Luddenham Advanced Resource Recovery Centre Submissions Report

Prepared for Coombes Property Group & KLF Holdings
May 2021

Submissions Report

J190749 RP38

Luddenham Advanced Resource
Recovery Centre
Submissions Report
Figure 1.2

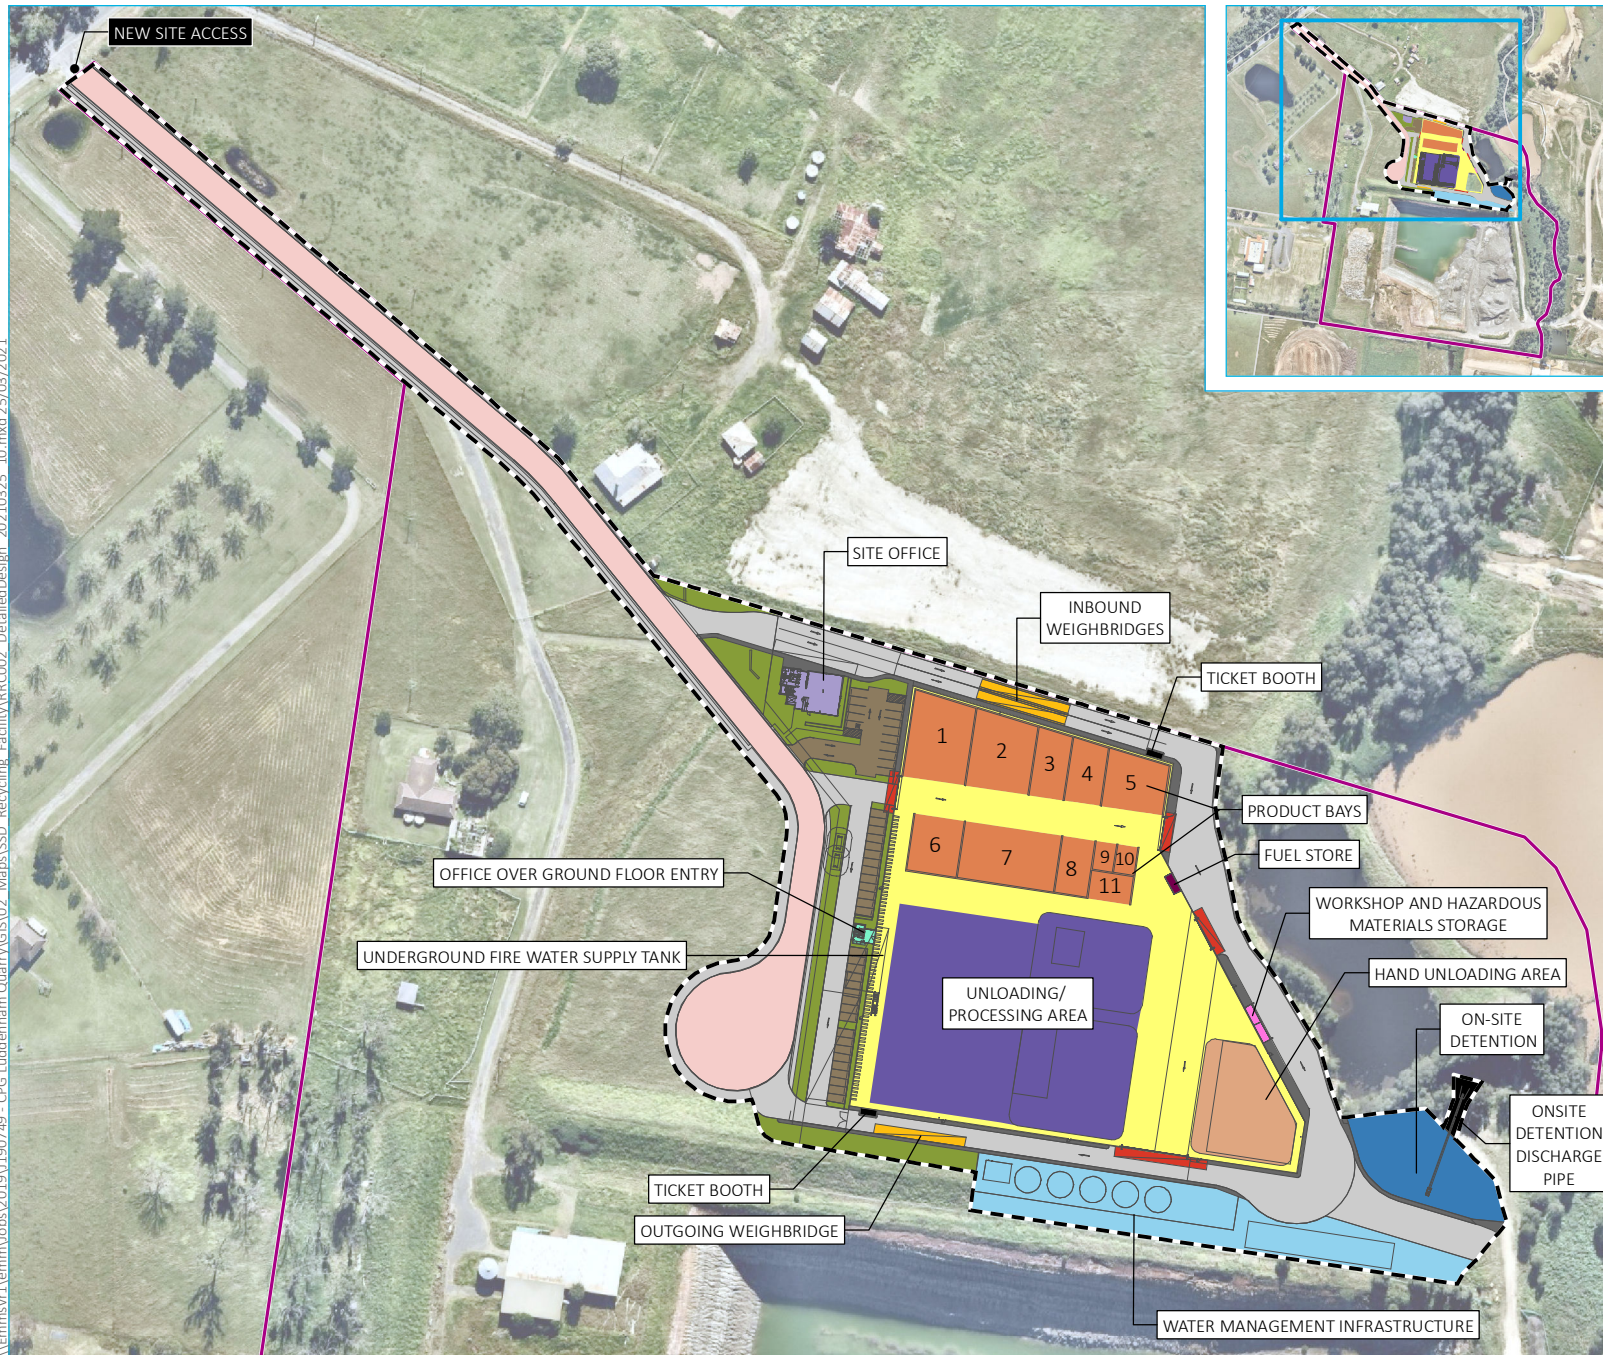
Minor refinements to the ARRC layout and design have also been made in response to submissions received and further detailed design. These refinements in comparison to the ARRC layout presented in the EIS are shown in Figure 3.2 and described below. The refined ARRC design overview is contained in Appendix D.

- Refinements to the size and footprint of the onsite detention basin. These refinements have slightly increased the biodiversity impacts of the project. This minor increase in impact has been assessed in the Revised BDAR (refer Section 3.3.4 and Appendix D).

- Addition of another inbound weighbridge to remove the potential for queuing to occur on the internal ARRC access road.
- Minor refinements to the location of ARRC warehouse entry and exit points to accommodate the safe movement of B-doubles through the ARRC site.

- Minor refinements to the layout and access arrangements of the light vehicle carpark in response to meet car park compliance with the relevant Australian standards.

Luddenham Advanced Resource
Recovery Centre
Submissions Report
Figure 3.1

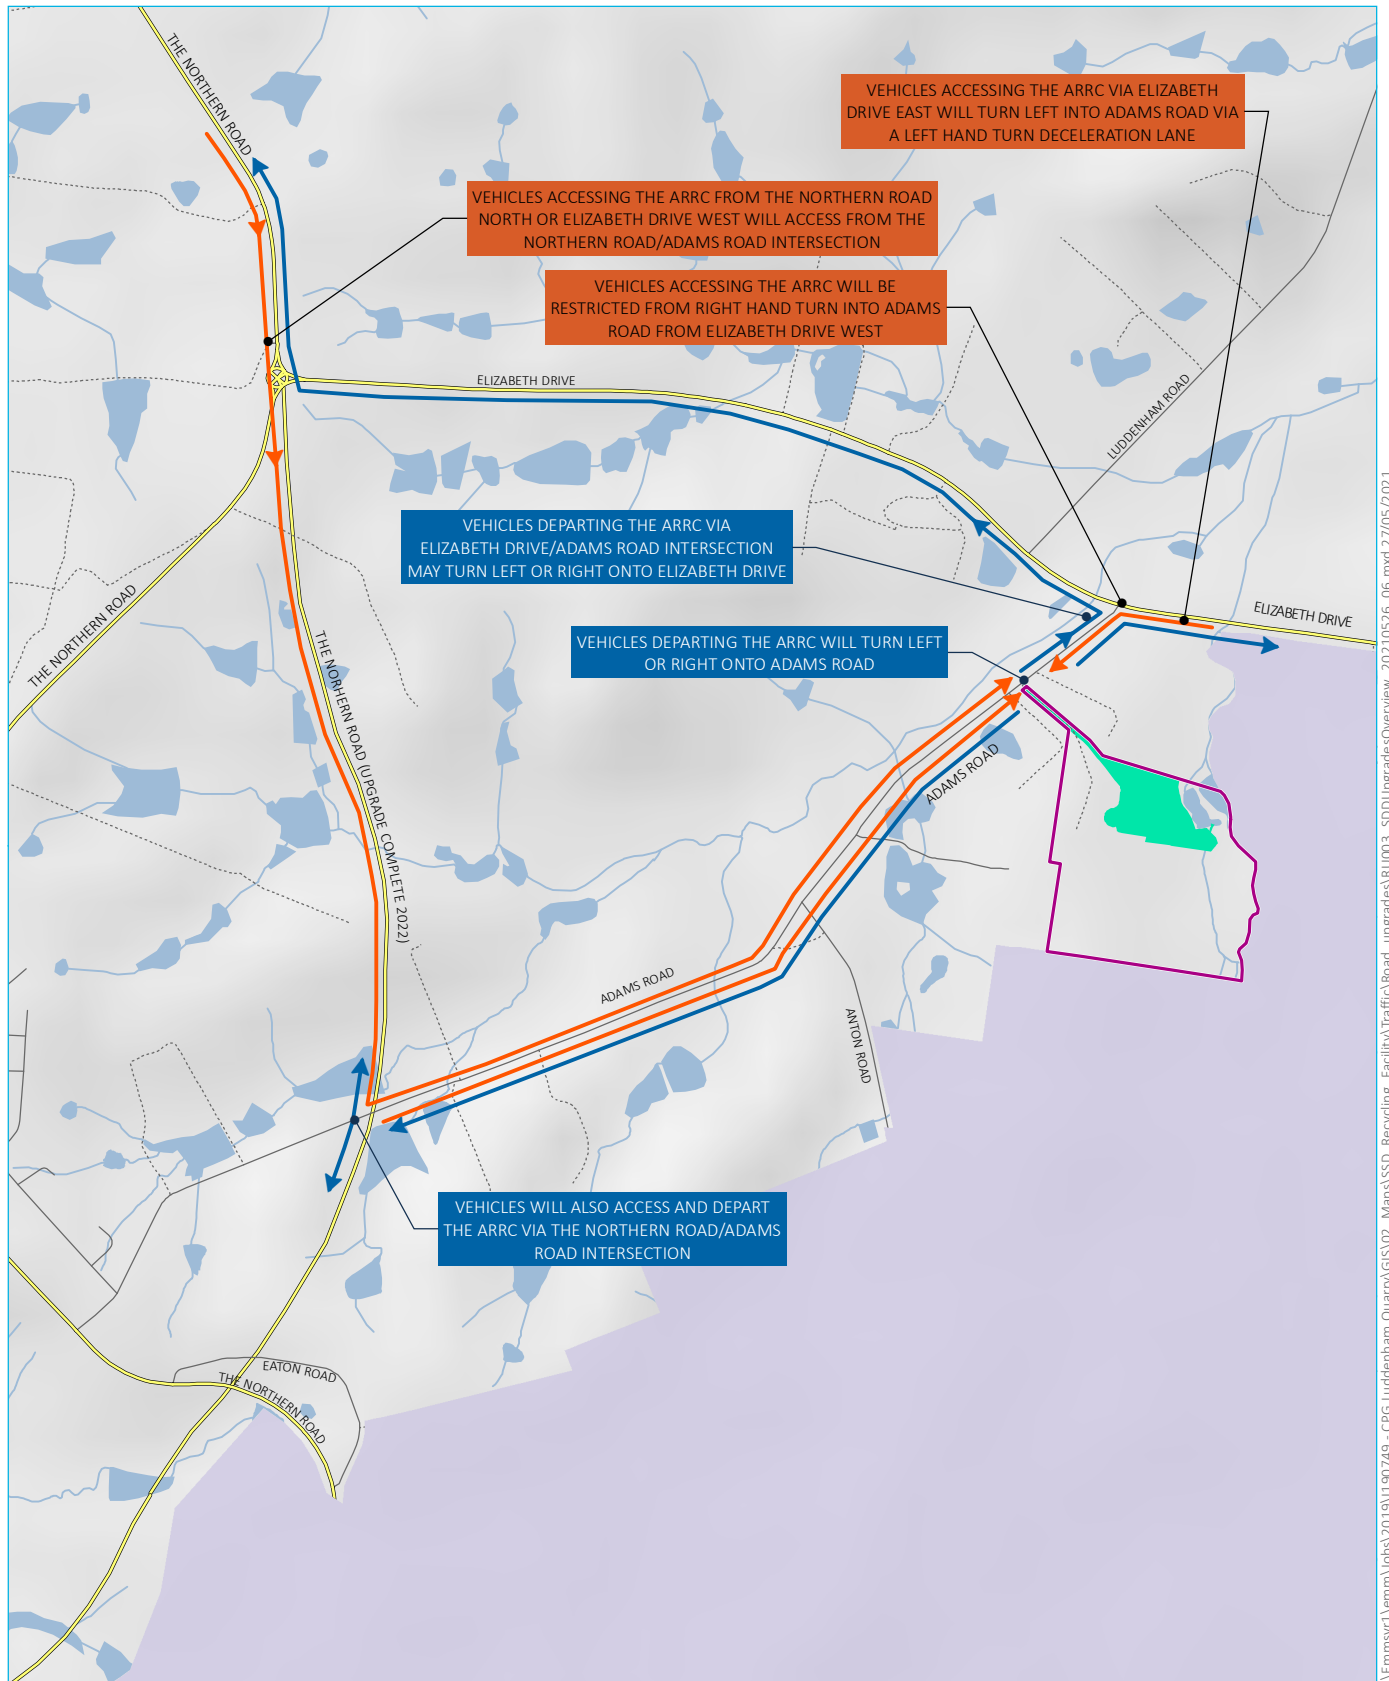
Consultation with TfNSW and Liverpool City Council has continued since the submission of the EIS. TfNSW raised safety concerns in relation to the right hand turn for heavy vehicles into Adams Road from Elizabeth Drive.

In response to TfNSW's concerns, CPG and KLF have updated their approach to ARRC access and have developed a revised transport strategy for the ARRC. The revised transport strategy was discussed at a meeting with TfNSW, Liverpool City Council and DPIE on 25 March 2021 (refer Section 3.2).

The revised strategy is shown in Figure 3.1 and proposes heavy vehicle and light vehicle access via Elizabeth Drive with the exception that no vehicles will access the site via Elizabeth Drive west. Access would also be provided via The Northern Road. Lifting the load limit on Adams Road south of the site would be enabled by CPG and KLF upgrading the pavement between the site access and Anton Road and upgrading the pavement between south of Anton Road by other parties.
